PLANT NAMES: Three Mile Island, Units 1 & 2

SUBJECT: THREE MILE ISLAND UNITS 1 AND 2
DOCKETS NO. 50-289 AND 50-320

APPLICANT'S RESPONSE
TO
QUESTIONS RAISED BY GOVERNMENTAL AGENCIES
ON THE
COMMISSION'S DRAFT ENVIRONMENTAL IMPACT STATEMENT

PLANT PLAN
THREE MILE ISLAND NUCLEAR STATION UNIT 1
FIGURE 1.1

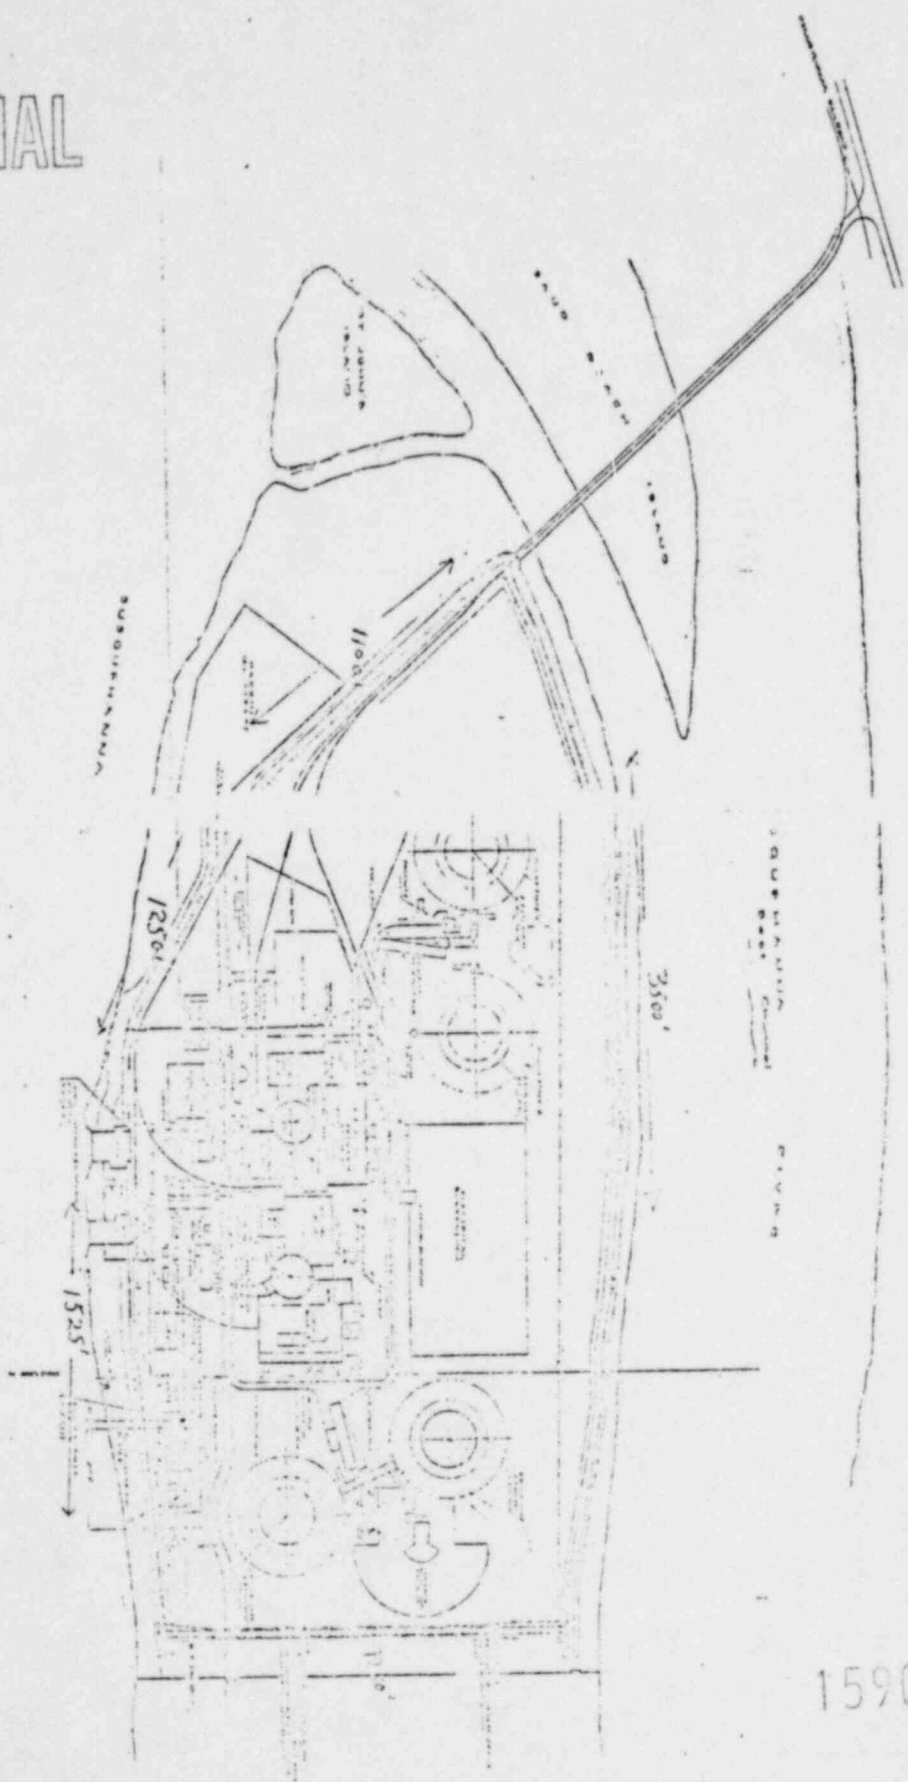
RESPONSE TO THE DEPARTMENT OF INTERIOR'S REQUEST
FOR DIMENSIONS OF THE DIKE AT THREE MILE ISLAND

The approximate dimensions of the periphery of the dike are as shown on the attached Figure 1-1. The following additional dimensions will be of interest:

1. Normal river water level in Yorkhaven pool - 278' above sea level.
2. Elevation to top of dike North end - 310' above sea level.
3. Elevation to top of dike on both the east and west sides of the island - Slopes from 309' to 305' above sea level.
4. Elevation to top of dike South end - 304' above sea level.
5. The dike is 20' wide with a 2:1 side slope.

Figure 1

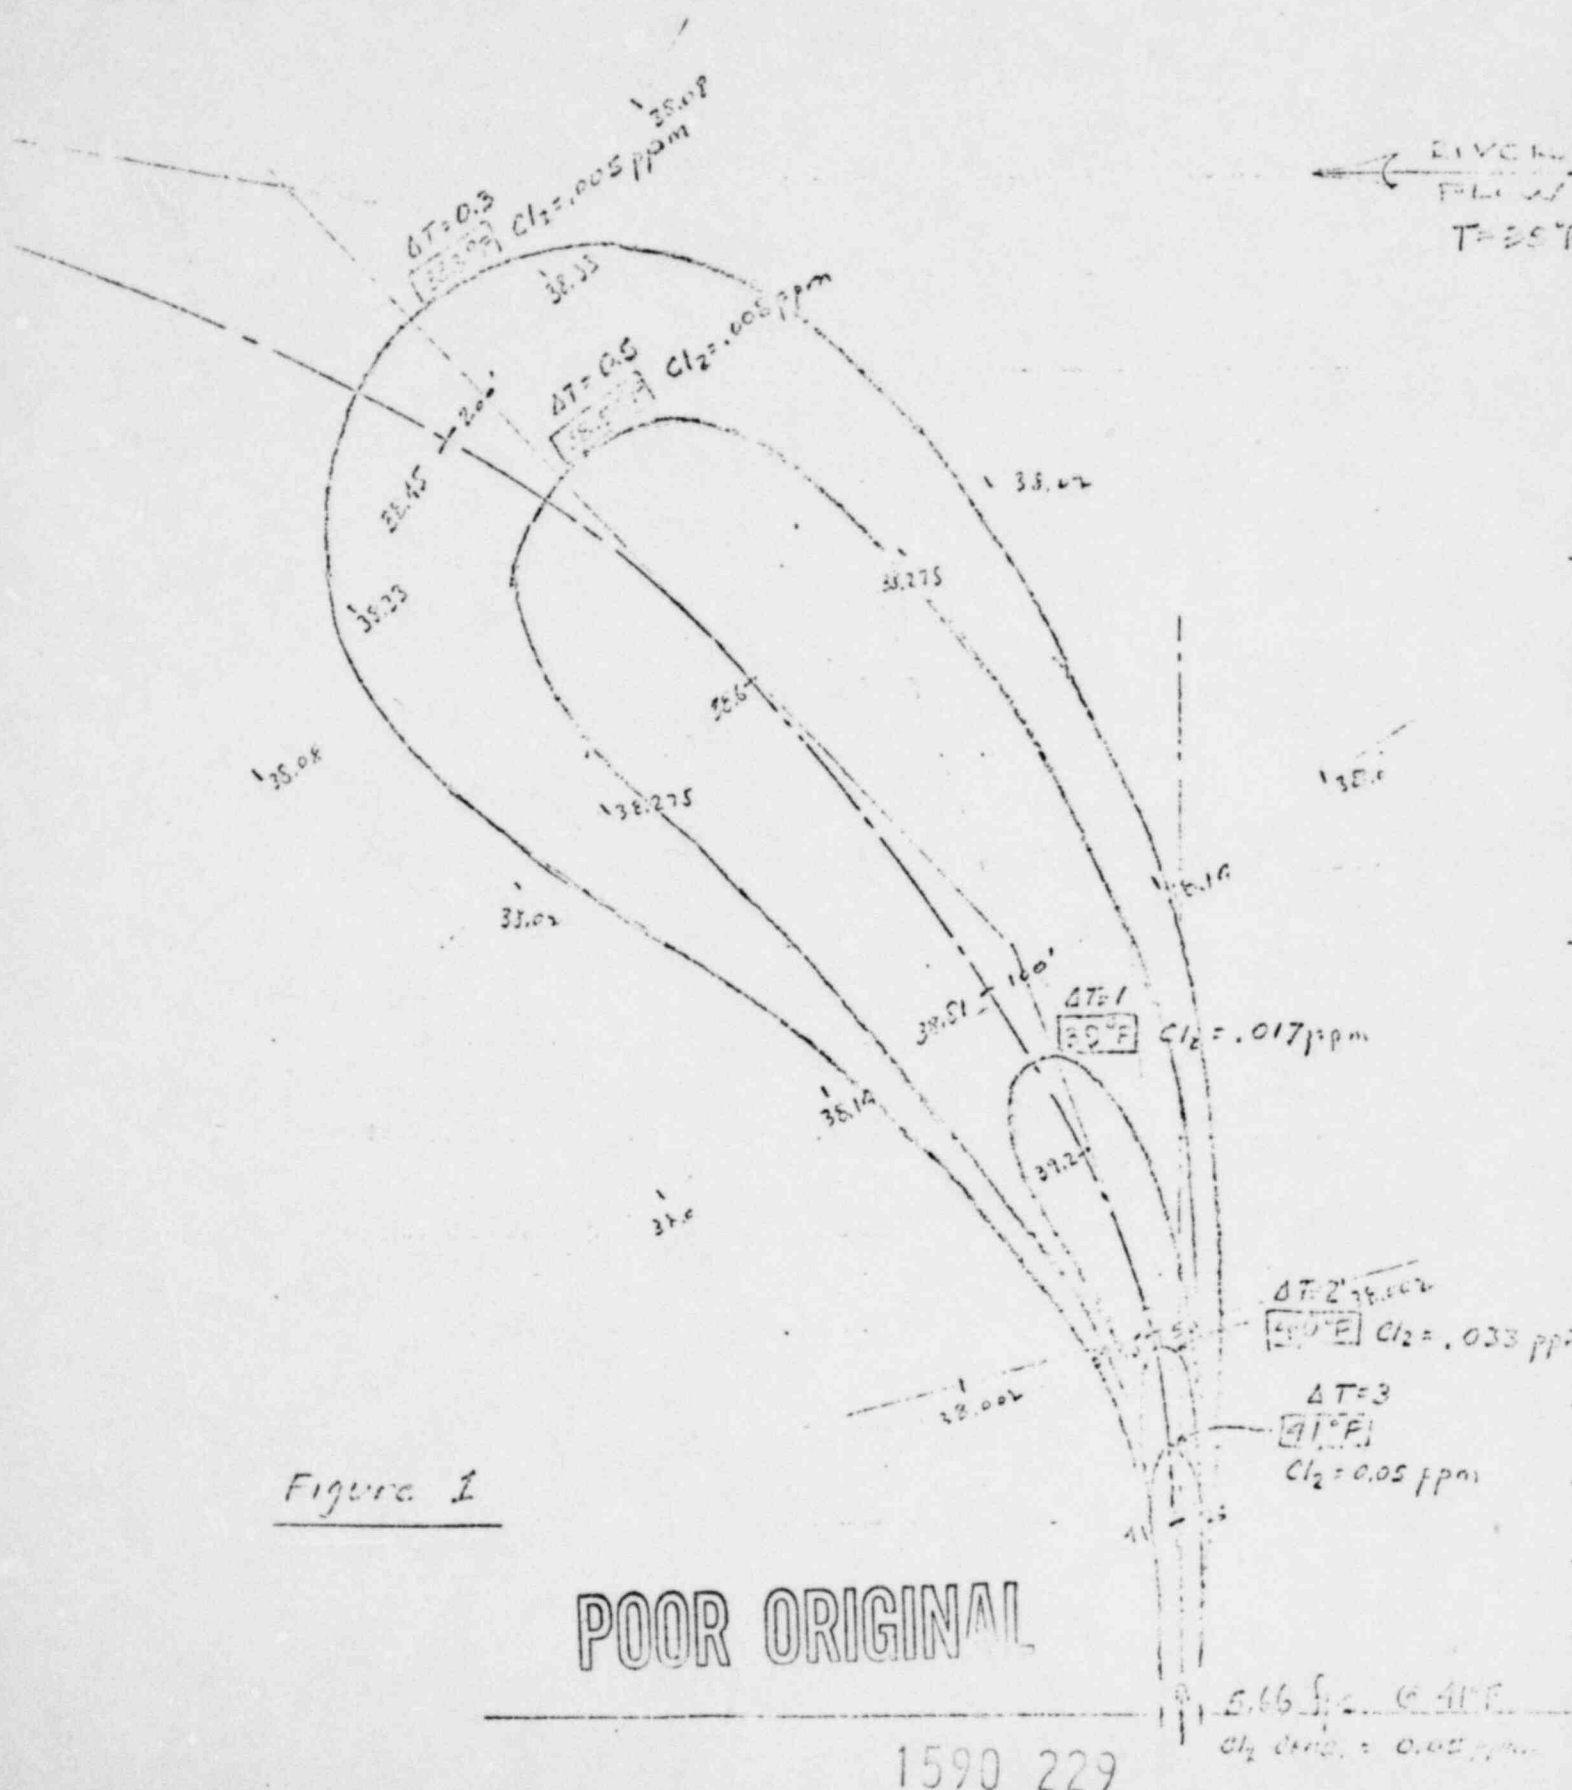
IN RESPONSE TO EPA QUESTION ON PLUMES

Cooling tower effluent is discharged continuously and, therefore, the plume shown in Figure 1 represents steady state conditions. The magnitude of the plume may be described in terms of the dimensions of the river and island. At the point of discharge the river is 1200 ft. wide, while the

plume, as defined by the 10 dilution contour, projects only 200 ft. into the river. The plume extends downstream about 120 ft. as compared to the length of Three Mile Island which is about 12,000 ft. The conditions of cooldown are, however, time dependent. The plumes resulting from these transient conditions are presented in Figures 2 and 3. Initially the cooldown flow is at a ΔT of 12.0°F (Figure 2). This temperature reduces to 3°F within 12 hrs. (Figure 3). The plumes under these conditions are not significantly larger than the tower effluent plume. The plume extends about 225 ft. into the river and about 220 ft. downstream.

It can be seen in reviewing Figure 1 that substances will undergo 10 dilutions in about 220 ft. of plume travel. The cooling water discharge at a $\Delta T = 12^{\circ}\text{F}$ (Figure 2) reaches 10 dilutions after about 300 ft. of travel. The cooling water discharge at a ΔT of 3°F (Figure 3) reaches 10 dilutions after about 250 ft. of travel.
